ZP-24-29; 323-325 College Street (RH, Ward 8) 323 Green Castle, LLC / Alpha Properties, LLC / Benjamin Frye

TO: Development Review Board
FROM: Garret King
DATE: March 6th, 2023
RE: ZP-24-29; 323-325 College Street

Request: Reapplication of ZP-22-416 for the proposed construction of a 4-unit building addition with associated utility work and minor grading.

Sv-1

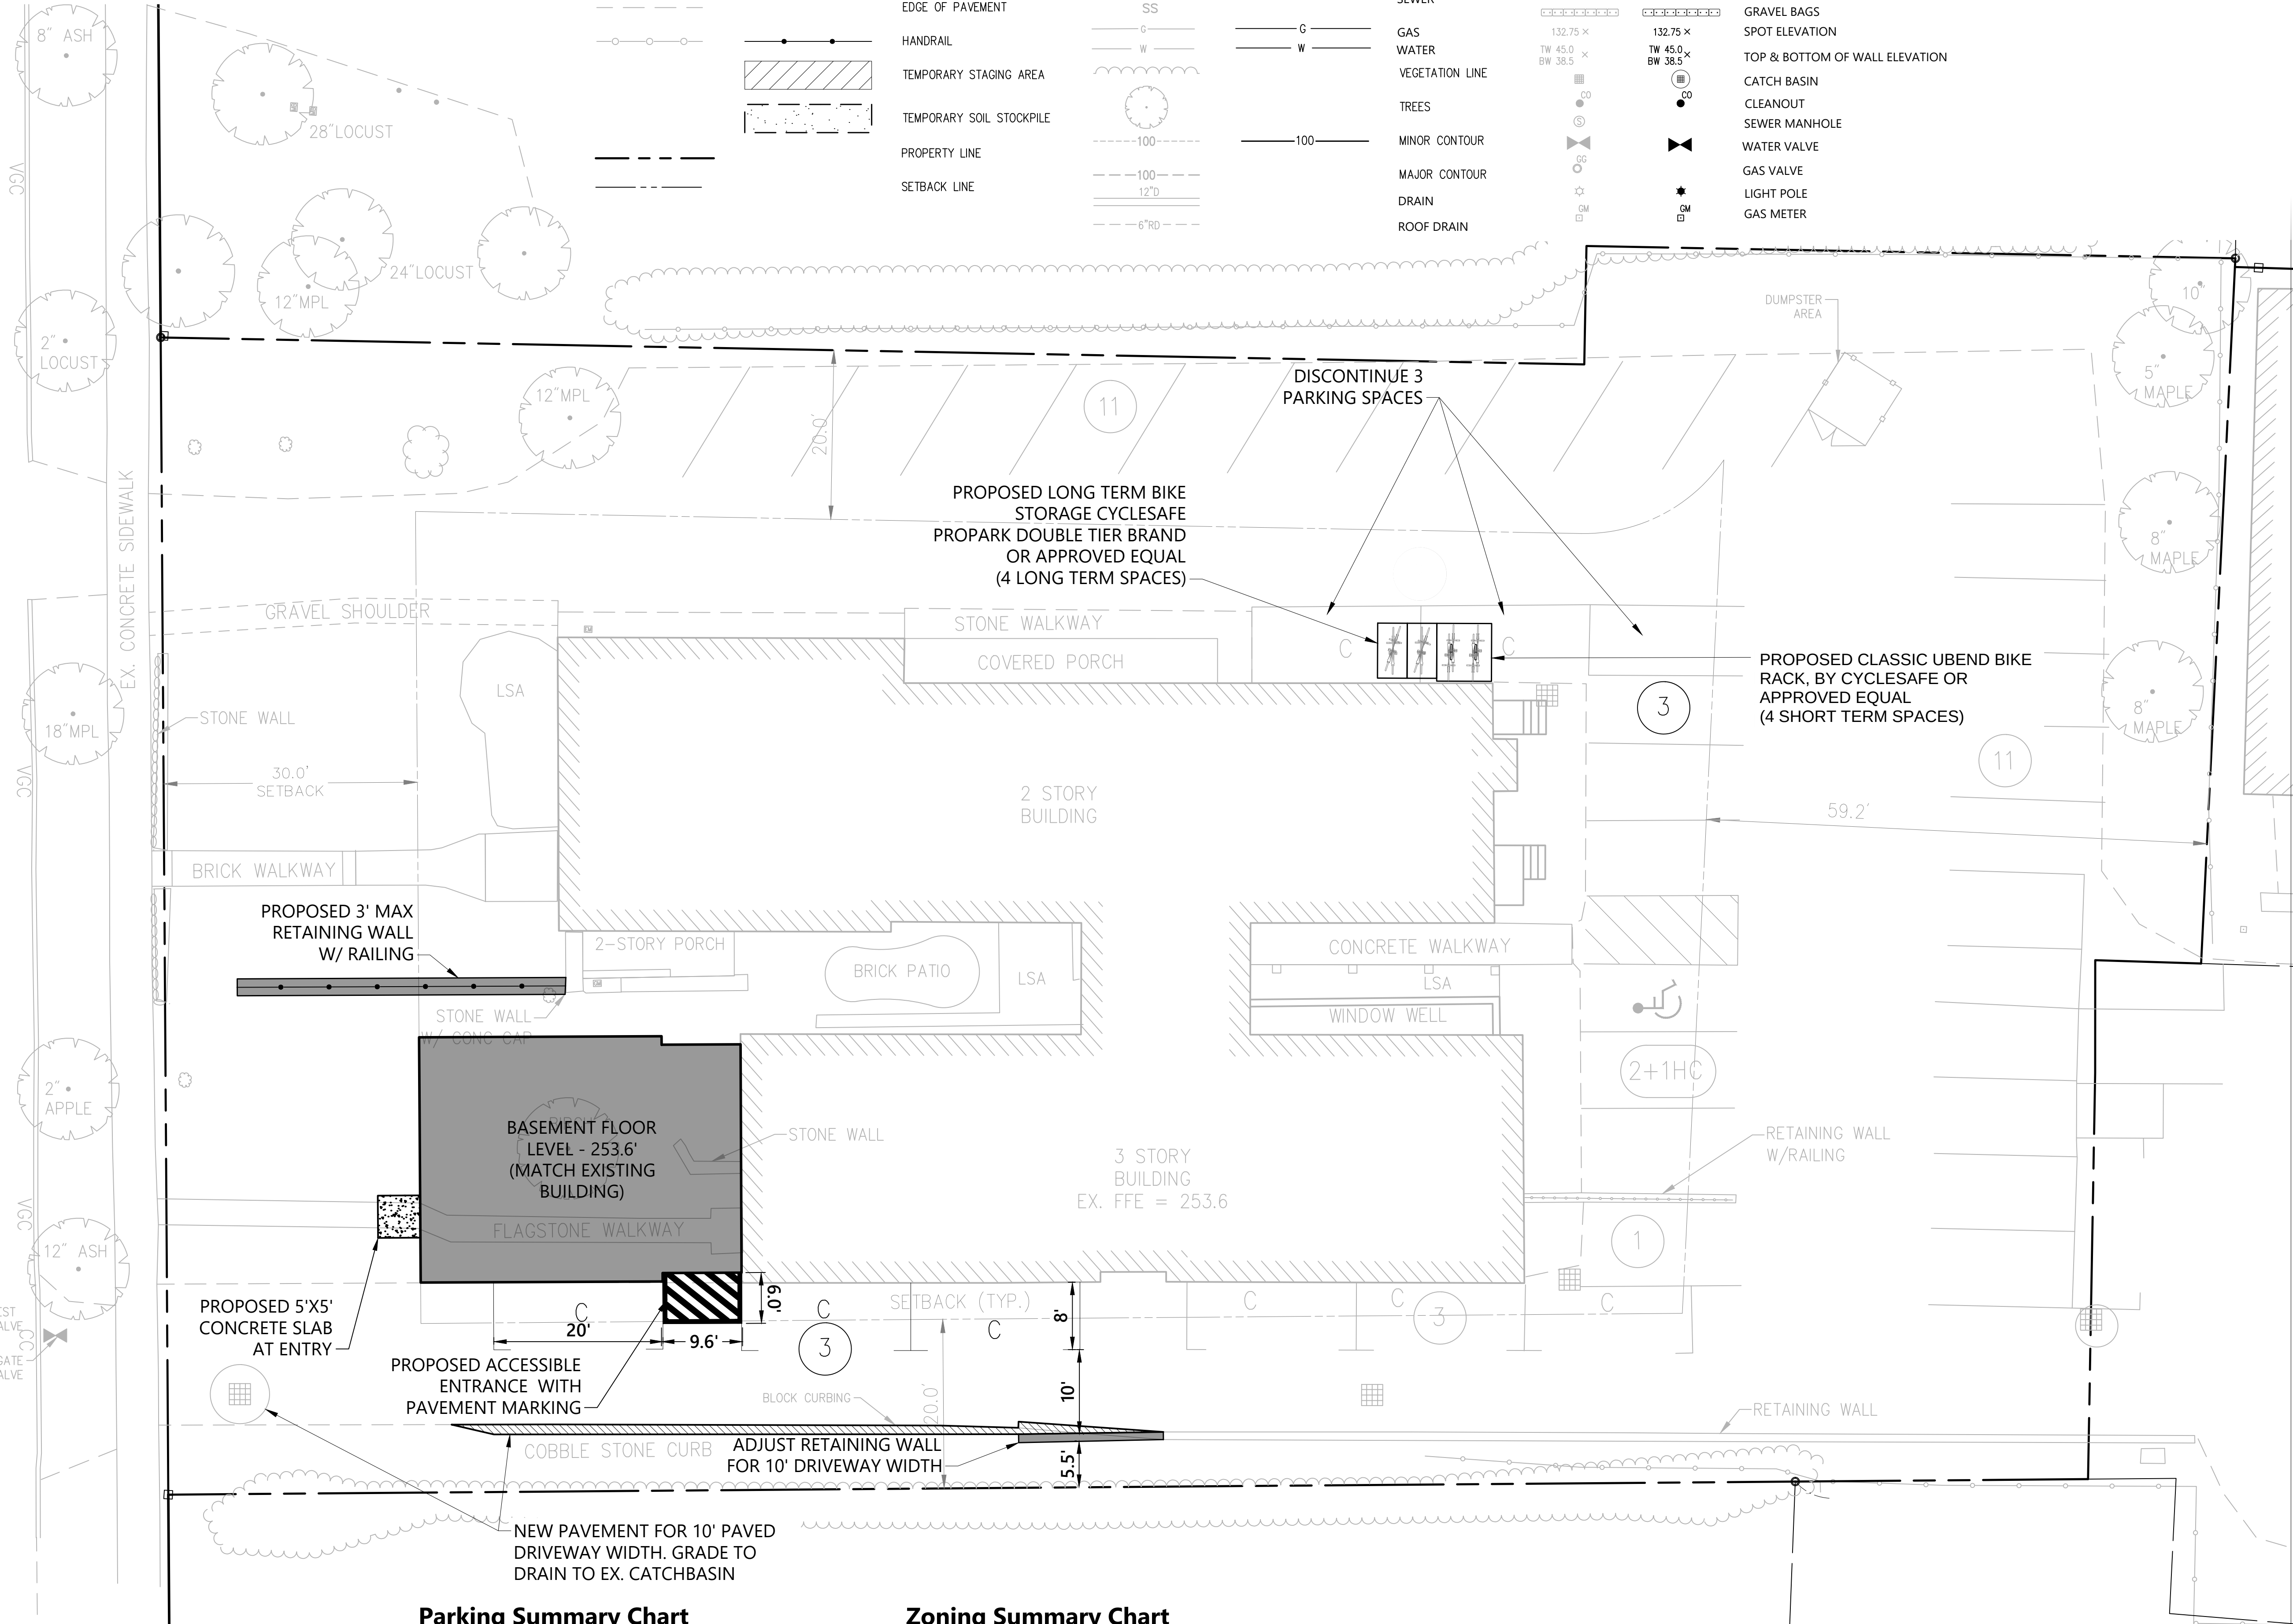
Plan Sv-1 shows a birch tree in the location of the proposed addition which will be removed. No other alterations to natural features are included. **Affirmative finding.**

C2.01

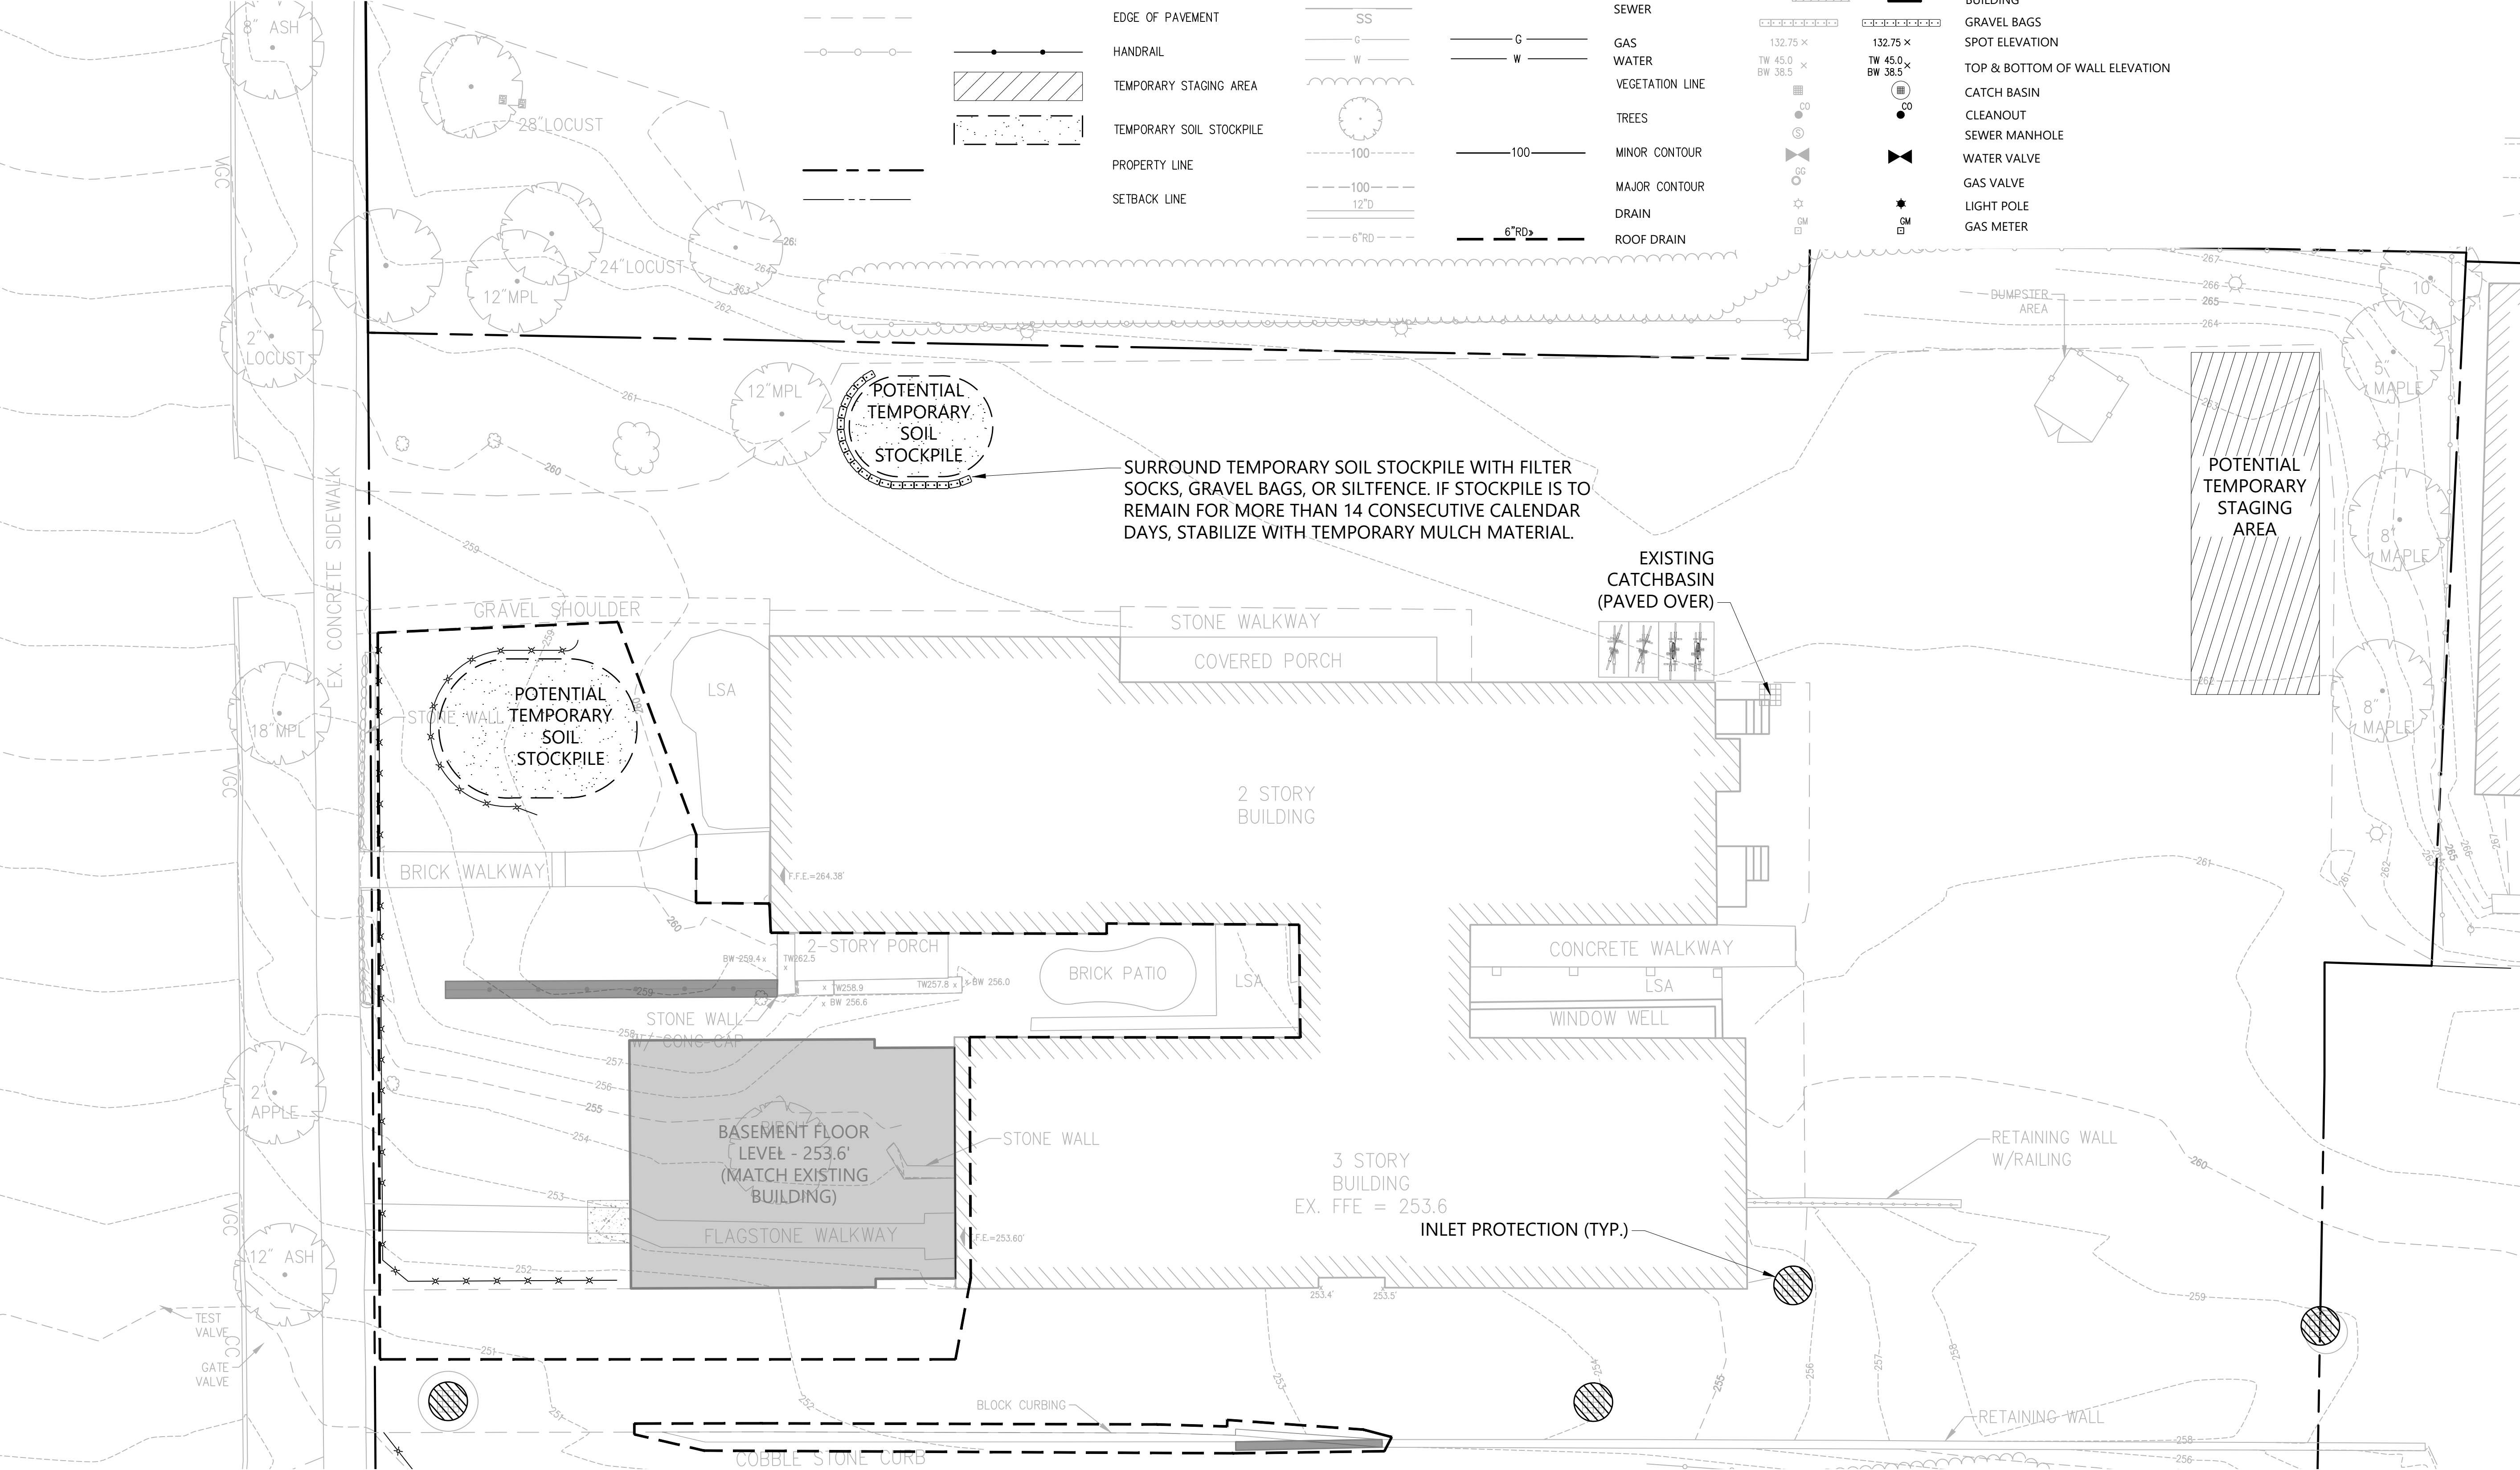
The applicant includes a plan for minor grading to accommodate the addition. The site grading and utility plan are C2.01. **Affirmative finding.**
